Access Compliance Report

Public Rights-of-Way

Intersection ID: 30499	Main Street: ORCHARD_GRASS_CT	Cross Street: PRAIRIE_GLEN_ST	Location:	N
ADA ID: 27A52F1EF43A	Ramp Type: PerpDiag	Initial Pass/Fail: Fail	Overall Compliance: No	Severity Score: 26.25
Codes/Mitigation Info/Possible Solution		Field Measurements/Component Compliance

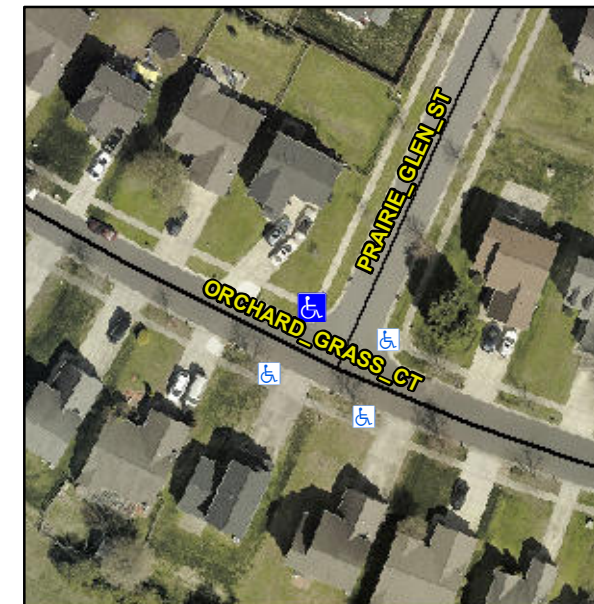
R304.2.2, R304.5.3

Compliance	Description	Data	Compliance	Description	Data
N/A	Ramp Length (in)	83.0	No	Ramp Slope (%)	12.9
Yes	Ramp Width (in)	48.0	No	Ramp XSlope (%)	2.4
N/A	Flare Type LT	N/A	N/A	Flare Type RT	N/A
N/A	Flare Slope LT (%)	N/A	N/A	Flare Slope RT (%)	N/A
N/A	Flare Traversable LT?	N/A	N/A	Flare Traversable RT?	N/A
N/A	Landing Length (in)	N/A	N/A	DWS Provided?	N/A
N/A	Landing Width (in)	N/A	N/A	DWS Contrast?	N/A
N/A	Landing Slope (%)	N/A	N/A	DWS Length (in)	N/A
N/A	Landing X Slope (%)	N/A	N/A	DWS Full Width?	N/A
N/A	Landing Curb? (Y/N)	N/A	N/A	DWS Offset (in)	N/A
N/A	Shared Landing?	N/A			
N/A	Gutter Ponding?	N/A	N/A	Gutter Slope (%)	N/A
N/A	Gutter Lip Ht (in)	N/A	N/A	Gutter X Slope (%)	N/A
N/A	Painted X Walk1?	No	N/A	Painted X Walk2?	No
	X Walk 1 Direction	To SW		X Walk 2 Direction	To SE
N/A	X Walk 1 Width (in)	N/A	N/A	X Walk 2 Width (in)	N/A
	X Walk 1 Slope (%)	1.5		X Walk 2 Slope (%)	3.0
	X Walk 1 X Slope (%)	3.3		X Walk 2 X Slope (%)	3.0

Remove & Replace Curb Ramp With Two New Directional Ramps or Equivalent.
